TECHNICAL EVALUATION
OF TMI-2 POST-DEFUELING MONITORED STORAGE
FACILITY OPERATING LICENSE NO. DPR-73

GPU NUCLEAR CORPORATION

DOCKET NO. 50-320

February 1992

Figure 5.1 Cutaway View of TMI-2 Vessel Following Completion of Defueling Effort

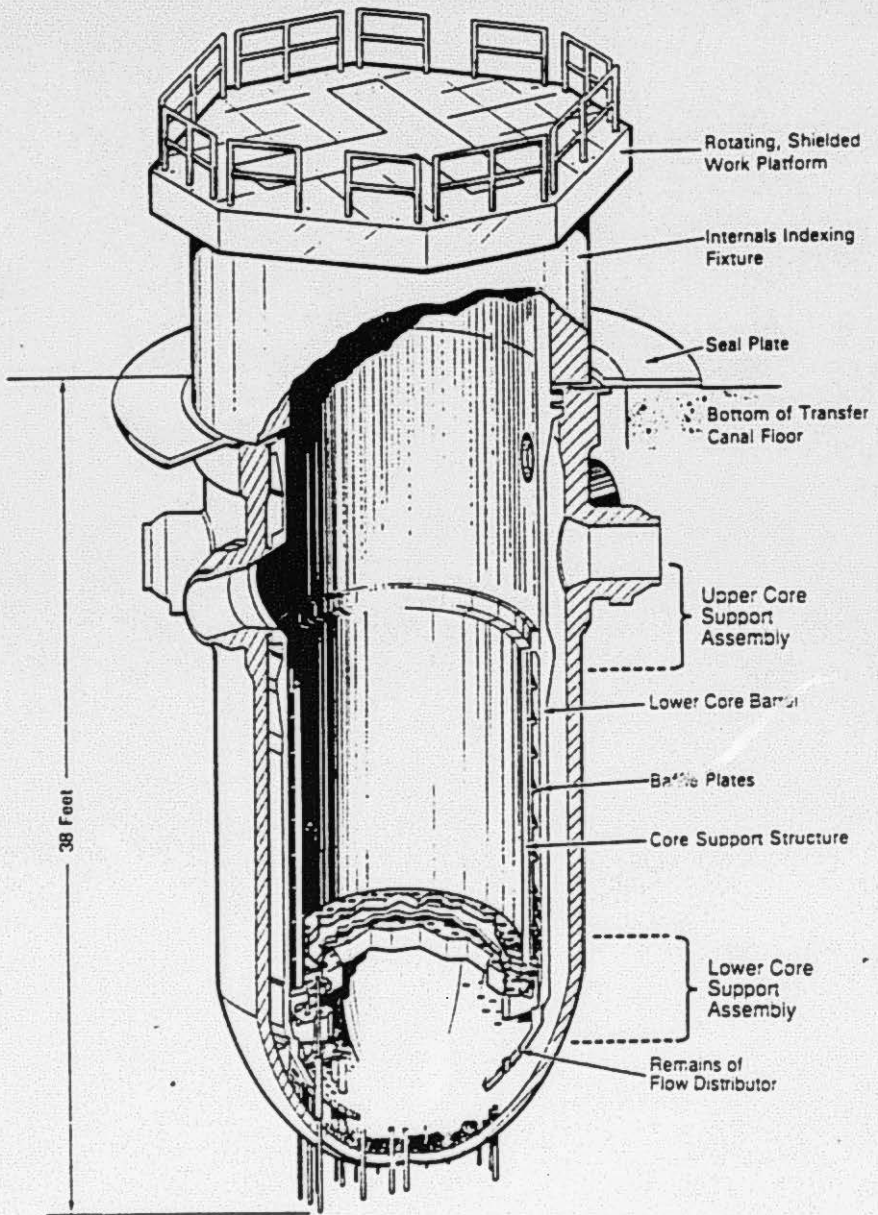
The staff reviewed the licensee's reactor vessel measurements. It selected several areas within the reactor vessel with the potential for uninventoried fuel and examined videotapes of the locations in detail. It determined that there was some additional fuel that the licensee had failed to include in the estimates; however, the amounts were insignificant (probably less than 2.2 pounds [1 kilogram]) relative to the reported quantity of fuel (i.e., UO_2) in the reactor vessel (1339 pounds [608.8 kilograms]). The staff decided to enlarge the audit sample size and examine additional areas. After additional evaluation and review, the staff concluded that the licensee had looked at and characterized the remaining fuel in all locations within the reactor vessel. The staff determined after reviewing the videotapes of the selected locations within the reactor vessel and the calculation of residual fuel based on the video inspections that the licensee's estimates of residual fuel (GPU 1990f) are reasonable and conservative.
